To the Durham Planning Board

Comments/suggestions on landscape plan for Mill Plaza Development Plan - 12/1/21

From John Parry, 5 Denbow Rd., Durham, NH

Landscape Notes on Sheet G 101 – My Comments in Bold Italics

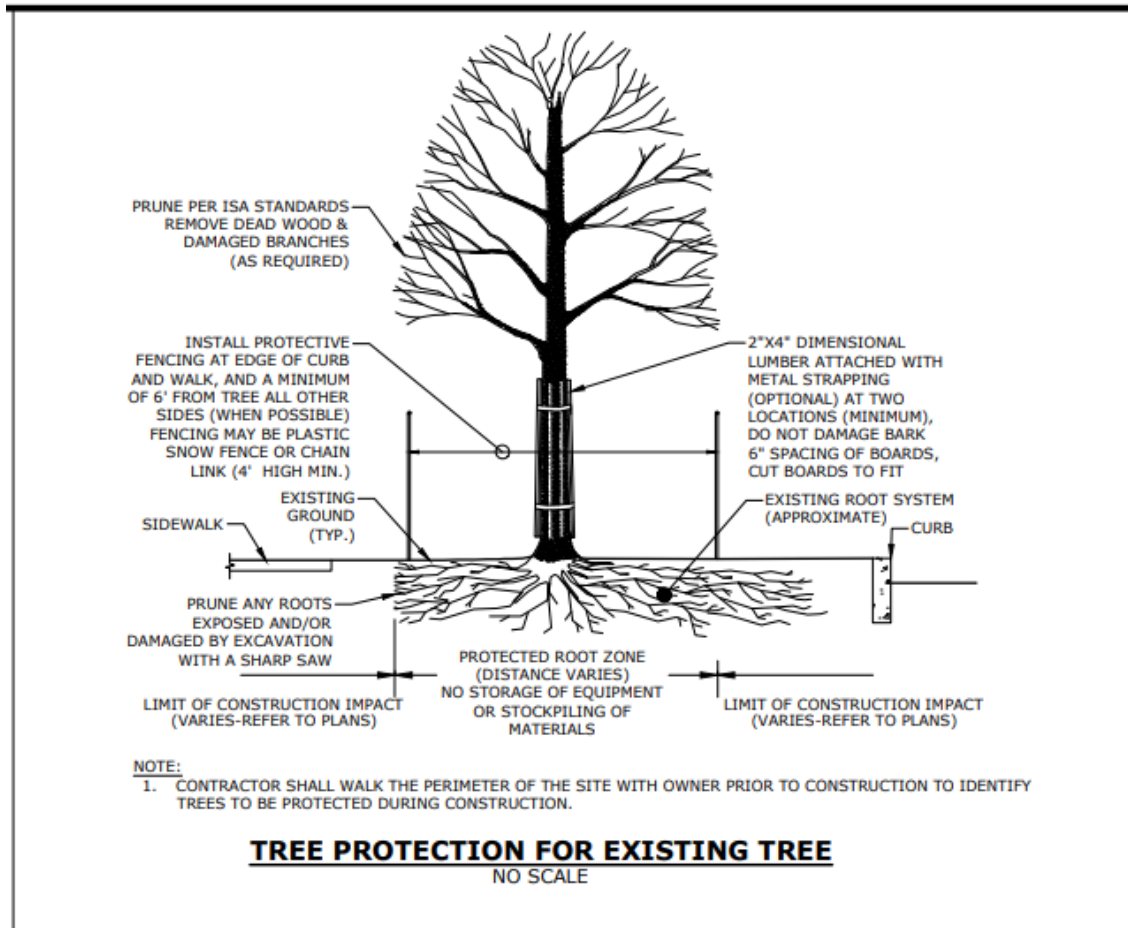
It is difficult to see on the plan which trees are identified for protection?

Protecting root zone around the tree is critical. Fencing at the drip line is an accepted industry standard. An alternative that is used is protecting a circle around the tree with a 1 foot for each 1 inch of tree diameter (measured at 4.5 feet above ground). The underlined wording above "or at an 8 foot minimum" is contradictory and not adequate for larger trees over 8" in diameter.

On Sheet C508 the figure below does not show or mention fencing? The protection standard for existing trees is unclear and needs to be confirmed.

4 DECIDUOUS TREE PLANTING: CENTER PARKING ISLAND
Scale: Not To Scale

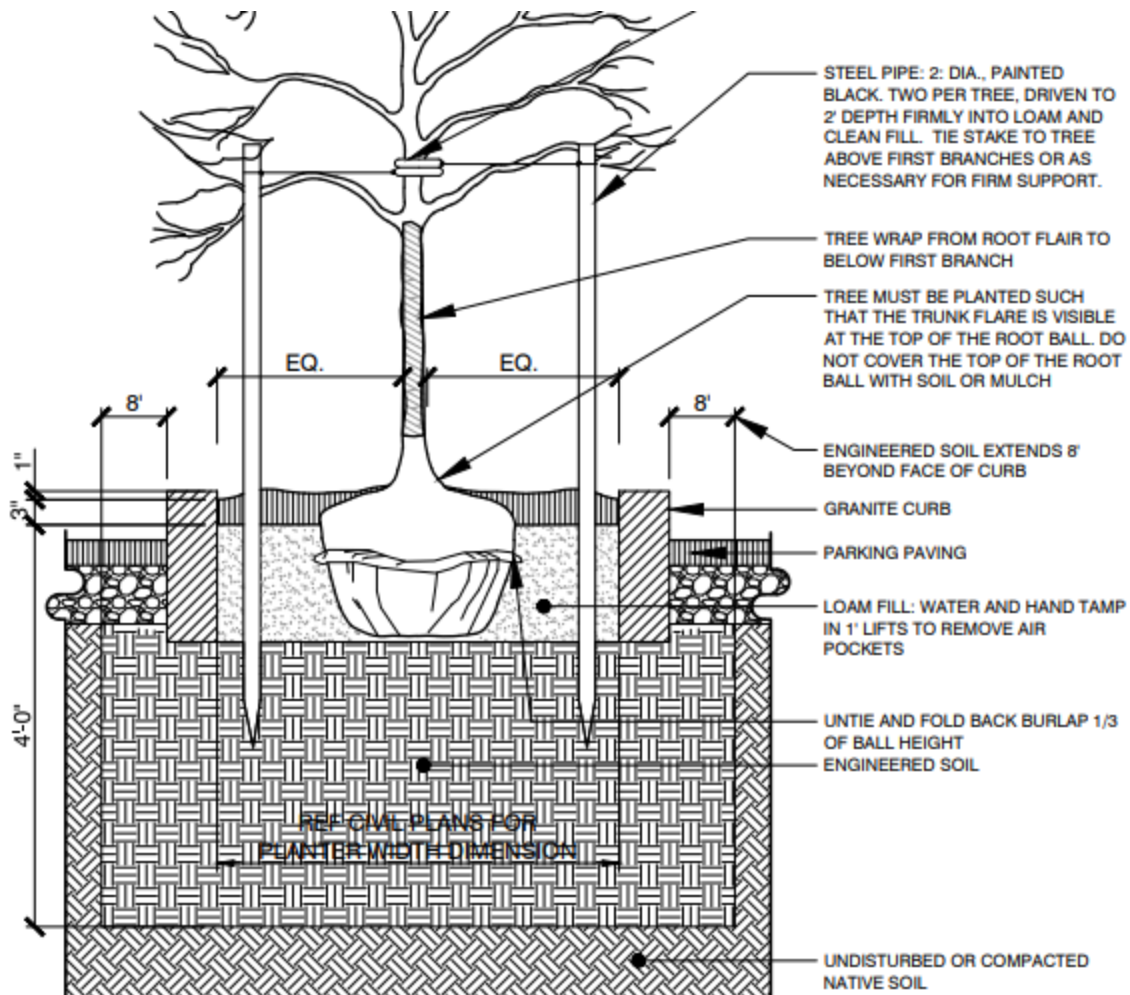
I am glad to see species were selected that will have a larger size at maturity, but I feel the width of the Islands should have been increased (to at least 8 feet) to allow adequate rooting space and branching space. Trees in the existing lot, and on main street are examples of what

happens long term without adequate rooting space. Most roots naturally grow horizontally from the root ball. I see the engineered soil extends to 8 feet under the soil. This will help, but does not totally make up for the limited rooting space at ground level. Also note that some of the species selected have shallow rooting behavior, so need to keep an eye on damage to pavement.

The crown spread of some of these trees at maturity may be up to 30' plus. It would be good to plan more width in the parking lot islands to avoid branch conflicts with vehicles, delivery trucks, snowplows, etc. Branches can be pruned up over time, but trees must be allowed to gain height before too much lower branch pruning can be done. Good species selection can help. Also, when ordering trees from nursery, contract wording can specify the height to which trees should be free of branching.

Planting Specs. - I would require the burlap and basket to be cut away 2/3rd of the way down the root ball.

Depth of loam fill should be even with root collar. The figure seems to show the loam well below the root collar.

A concern I had from previous designs was that the existing compacted under-soil (underneath the loam fill) would not drain water from the islands. I see this new design includes 2' of engineered soil underneath the root ball. Will this provide adequate drainage?
